HISTORIC LANDMARK COMMISSION
APPLICATION FOR A CERTIFICATE OF APPROPRIATENESS
FEBRUARY 7, 2024
HR-2024-005082
RISHER-ROACH BUILDING, PART B
511 EAST 6TH STREET

PROPOSAL

Rehabilitate the building and replace the storefront.

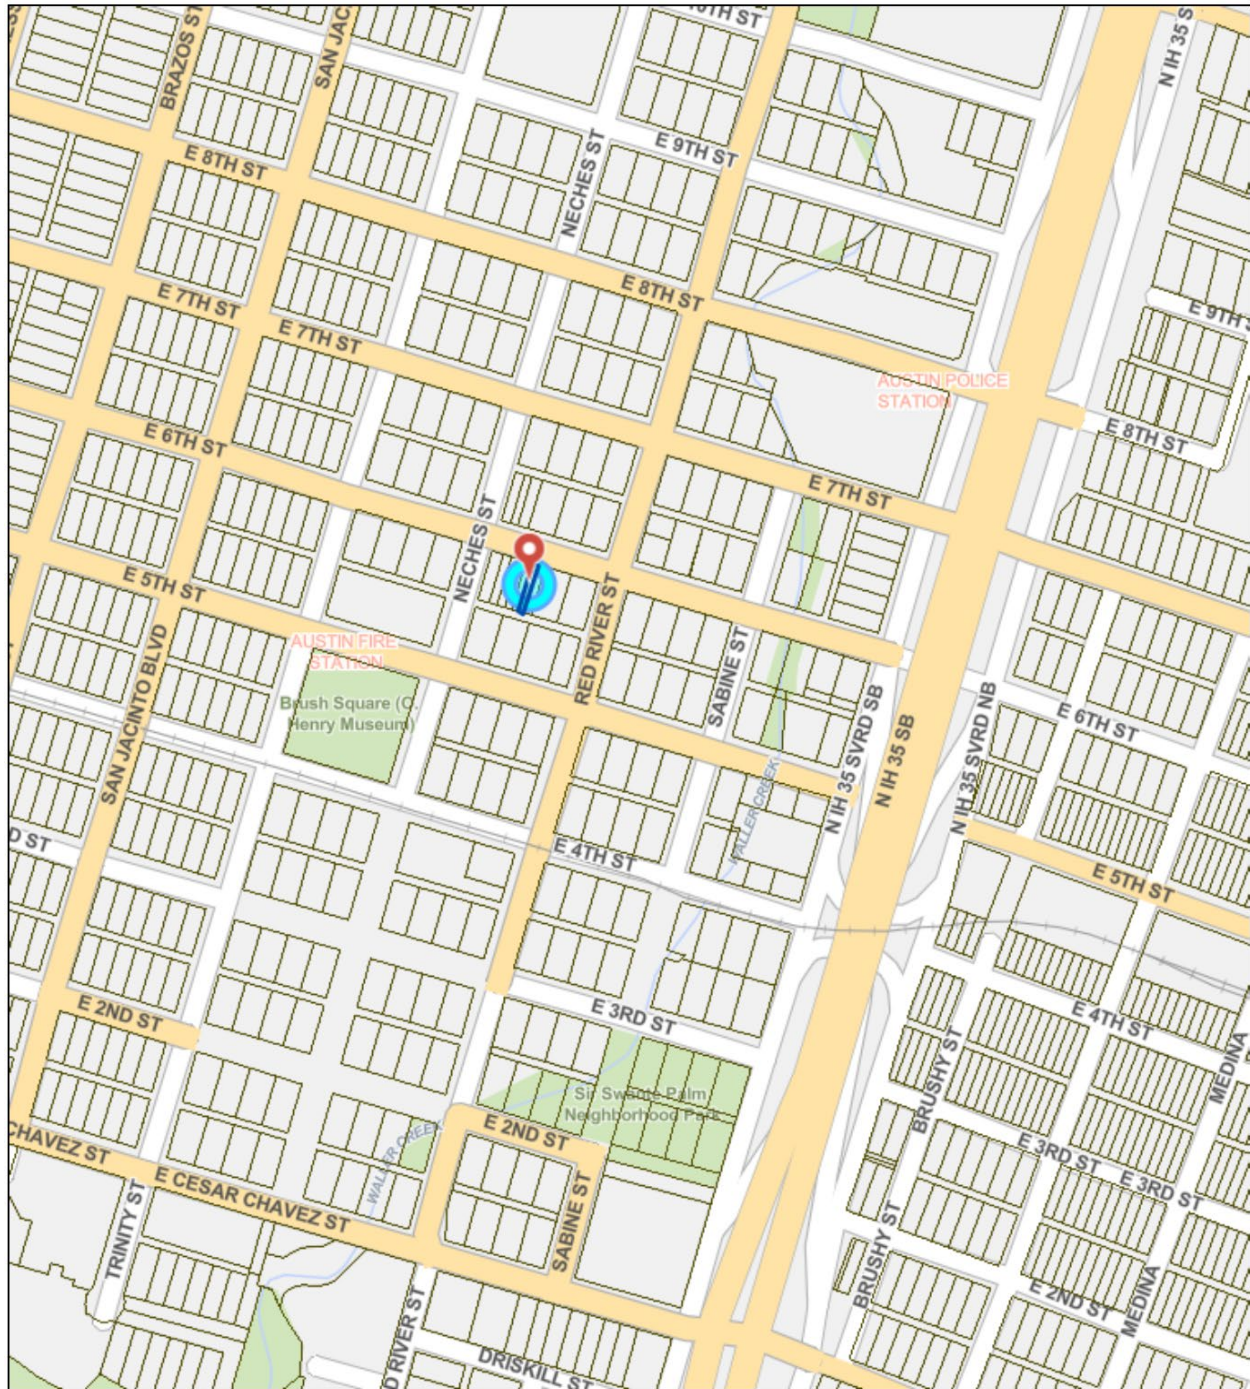
Explore paint removal options if possible. Consider restoring original arches.

Approve the application.
